Licence Number L8904/2015/1

Licence Holder Cleanaway Solid Waste Pty Ltd

Premises Banksia Road Putrescible Landfill
Banksia Road
CROOKED BROOK WA 6236
Being Lot 2 on Plan 65861
Certificate of Title Volume 1670 Folio 568

Amendment

Appendix 2: Premises Map

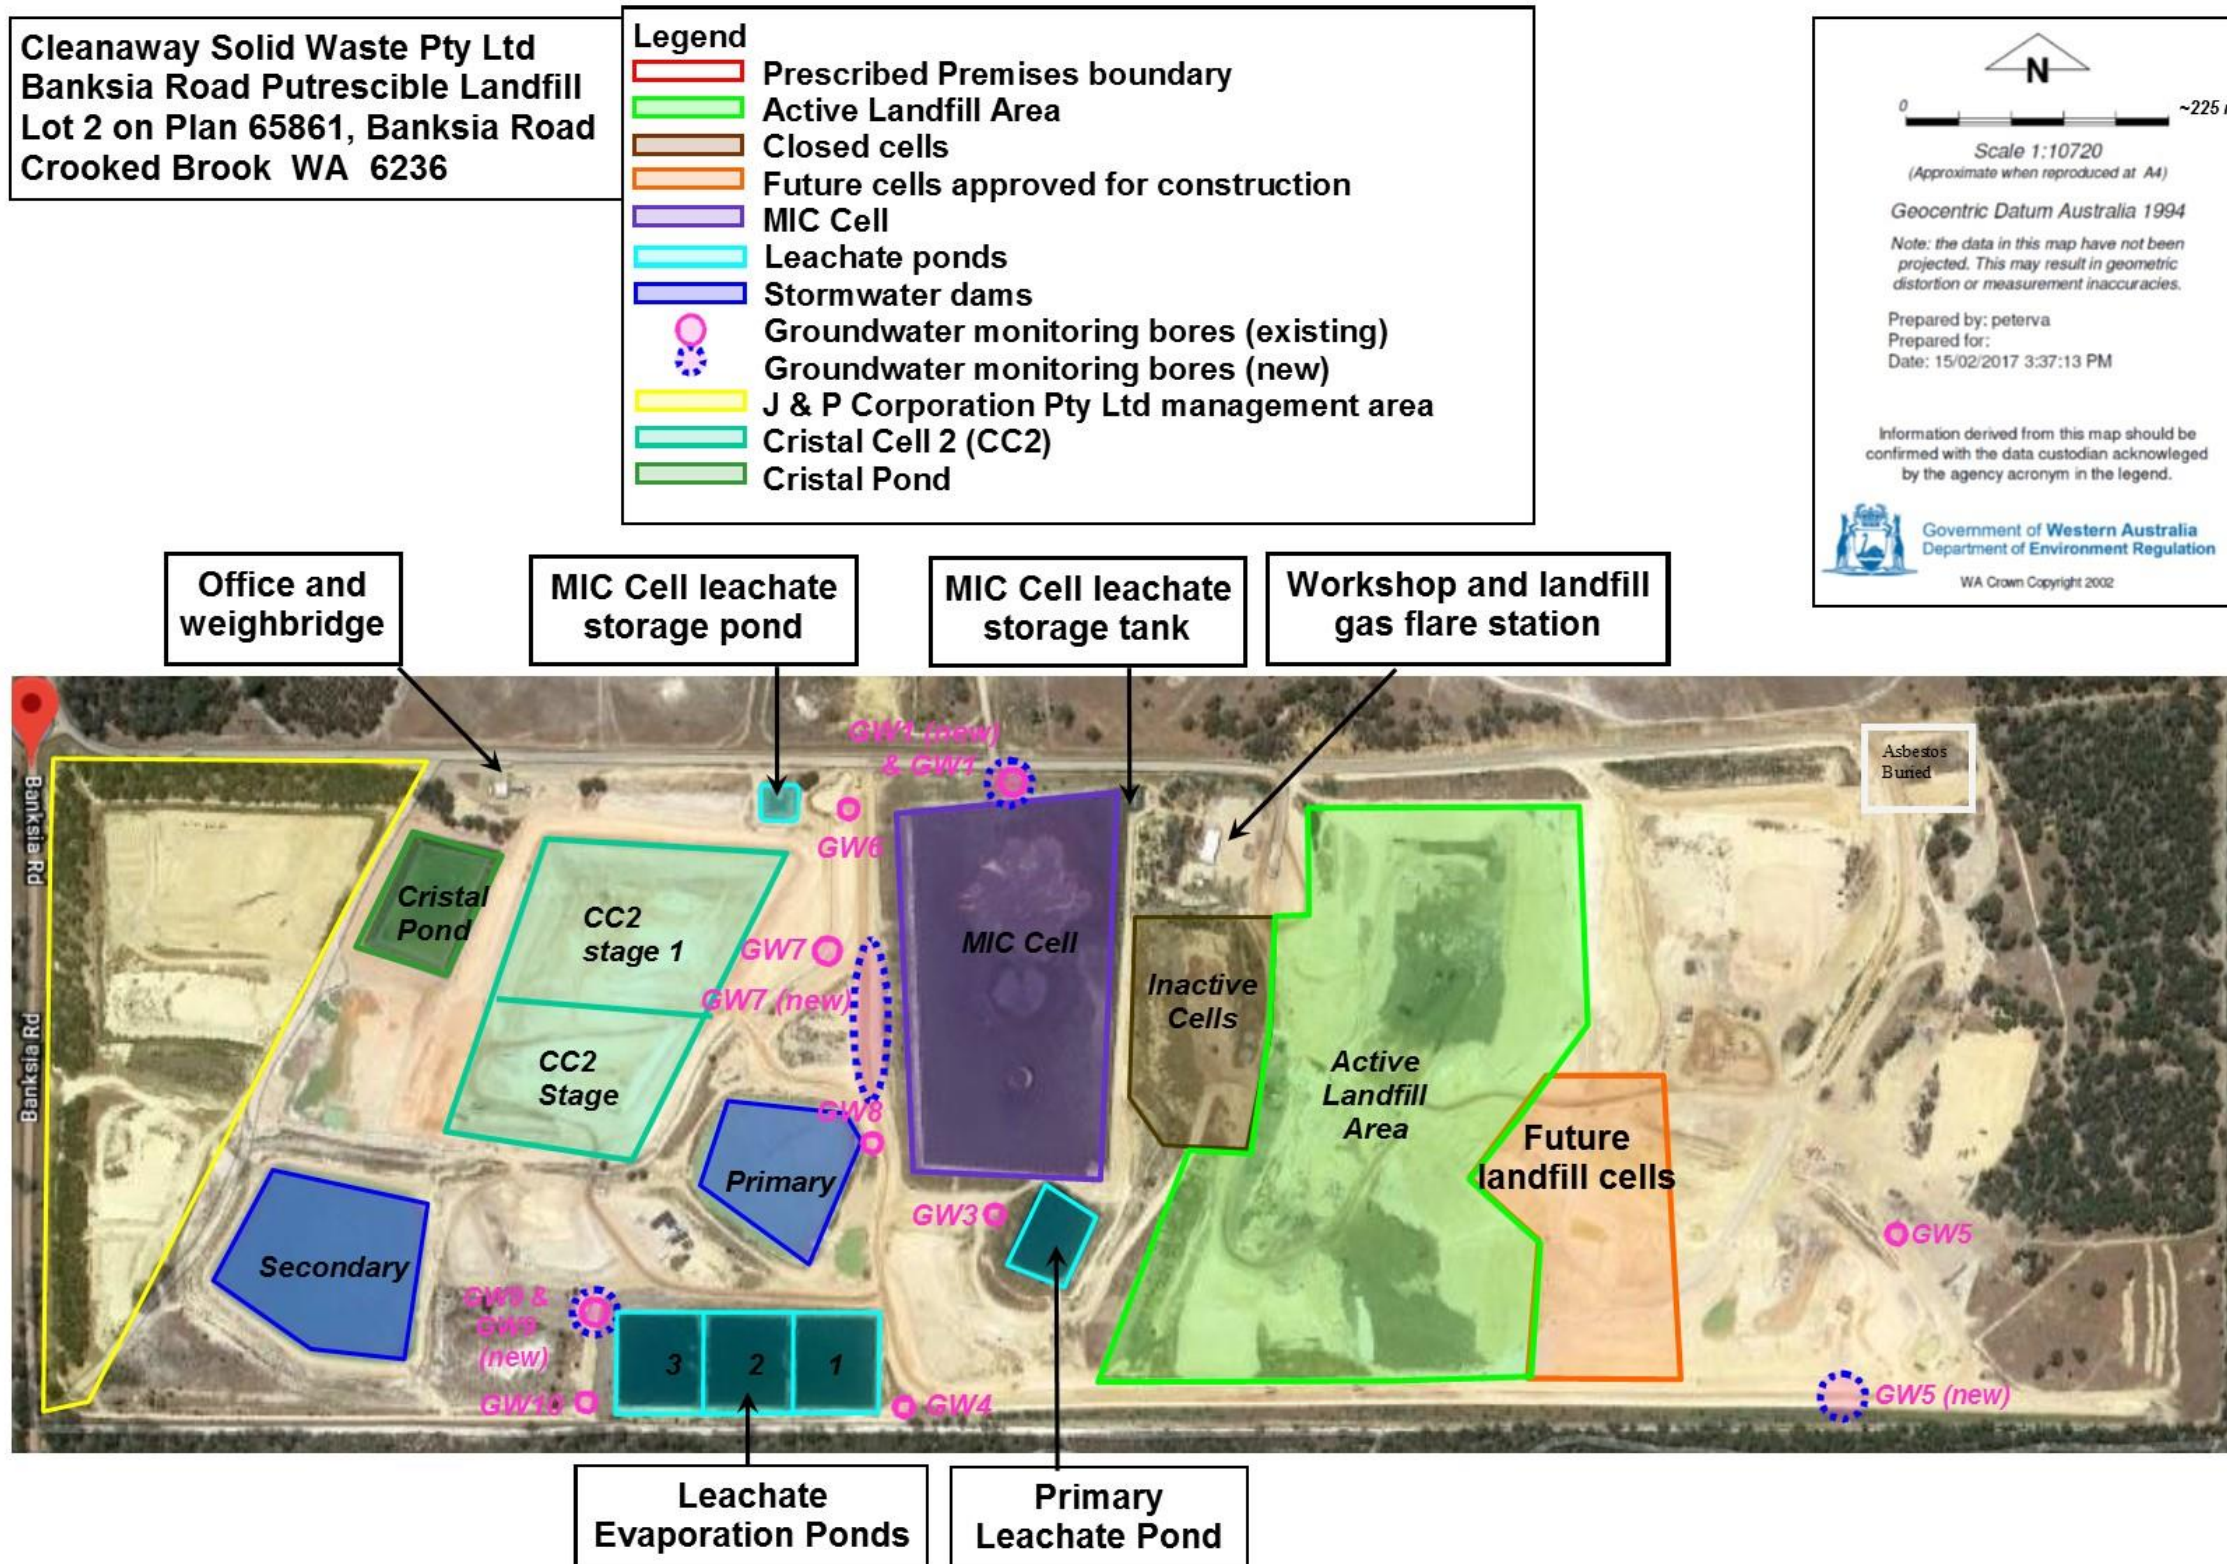
7. The Existing Licence is amended by the deletion of Premises Map 1 in Schedule 1: Maps and the insertion of the Premises Map shown in Appendix 2.
8. The Existing Licence is amended by the addition of Condition 1.4.15.
 - 1.4.15 The Licence Holder shall ensure that the unloading of Cristal pigment waste occurs on an impervious hardstand area.
